CITY OF INKSTER PLANNING COMMISSION MEETING AGENDA

Subject: Special Land Use, Site Plan, and Planned Unit Development Review for Lemoyne Gardens
Multifamily Housing Phase I: Parcel 44-013-05-0008-000
Location: Lemoyne Gardens
Zoning: RM, Restricted Multifamily District
Project #: SLU 22-36; SP 22-37

Subject: Special Land Use for a proposed Child Care Facility 7-12 occupants
Location: 26260 Stollman Drive (*Parcel ID 44-016-02-0271-000*)
Zoning: R-1B, One Family Residential District
Project #: SLU 22-33

Notes to the above photo and landscaping table. See table for additional detail. All shading is approximate / non-all-inclusive.

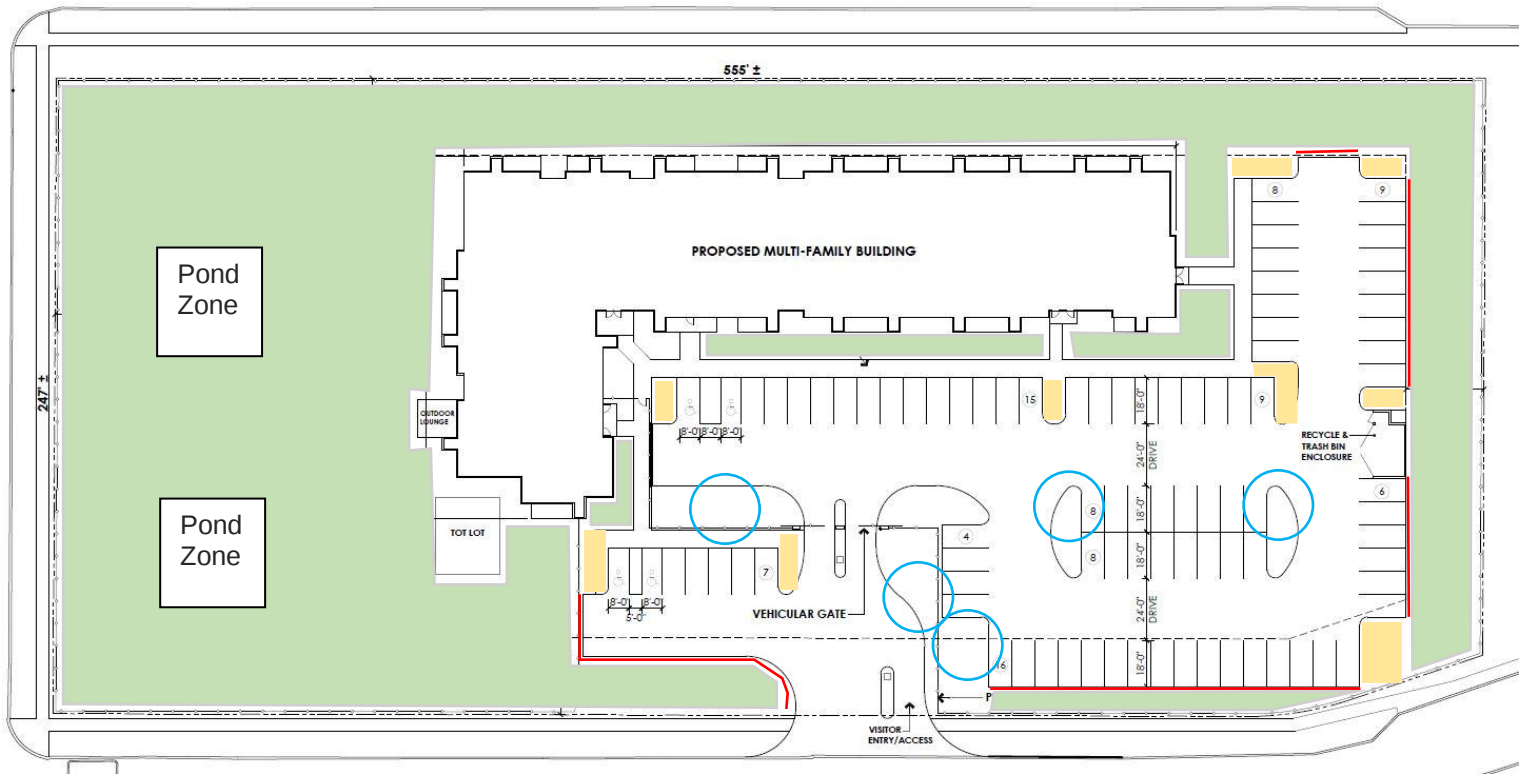
Criteria	Required	Proposed	Comments
Right-of-Way: Deciduous Trees	1 per 35 ft. Henry Ruff: 555 ft. = 16 Liberty: 247 ft. = 7 Klink: 559 ft. = 16	17 trees 7 trees 16 trees	In compliance
Right-of-Way: Ornamental Trees	1 per 75 ft. Henry Ruff: 555 ft. = 8 Liberty: 247 ft. = 4 Klink: 559 ft. = 8	8 trees 4 trees 8 trees	In compliance
Planted Yard Area Trees	1 per 3,000 SF	<u>Undetermined</u>	<u>The applicant must provide the total planted yard area first (this includes all planted lawn area and the detention basin, but not the pond zone) See photo below.</u>
Parking Lot: Interior Landscaping	5% of ±20,000 SF impervious area = 1,742 SF	3,638 SF	In compliance.
Parking Lot: Trees	1 deciduous tree per 150 SF of required interior landscaped area = 1,742 / 150 = 12 trees	<u>5 AB + 2 QB</u> <u>= 7 trees</u>	<u>An additional 5 deciduous trees are required within the specified interior landscaped area. See photo below.</u>

Curbing (General)	Concrete curbing is required along all landscape areas	<u>Not specified.</u>	<u>Concrete curbing must be shown along the entire parking lot perimeter and landscaped areas.</u>
Parking Lot: Perimeter Deciduous Trees	1 deciduous tree per 25 linear ft.	Undetermined	<u>The applicant must provide the perimeter dimensions in linear feet first (this will not include the perimeter that abuts a sidewalk or landscaped island) See photo below.</u>
Parking Lot: Perimeter Ornamental Trees	1 ornamental tree per 35 linear ft. = (approx.. 387 ft. / 35 ft.) = 11 trees	Undetermined	<u>The applicant must provide the perimeter dimensions in linear feet first (this will not include the perimeter that abuts a sidewalk or landscaped island) See photo below.</u>
Parking Lot: Perimeter Shrubs	Continuous hedge of shrubs, no more than 30-inches on center	<u>Shrubs have been provided, though gaps exist along the perimeter.</u>	<u>The applicant must provide the perimeter dimensions in linear feet (this will not include the perimeter that abuts a sidewalk or landscaped island) See photo below.</u>

Snow Storage	Plant materials must be hardy, salt-tolerant groundcover	Snow storage areas not specified.	<u>The applicant must show snow storage areas (and hardy landscaping if needed)</u>
Irrigation	Automatic or drip irrigation required	<u>Not specified.</u>	<u>An irrigation system must be provided and detailed on a revised landscape plan..</u>

(Green) The applicant must provide a calculated total of planted lawn area on-site and provide the required tree planting.
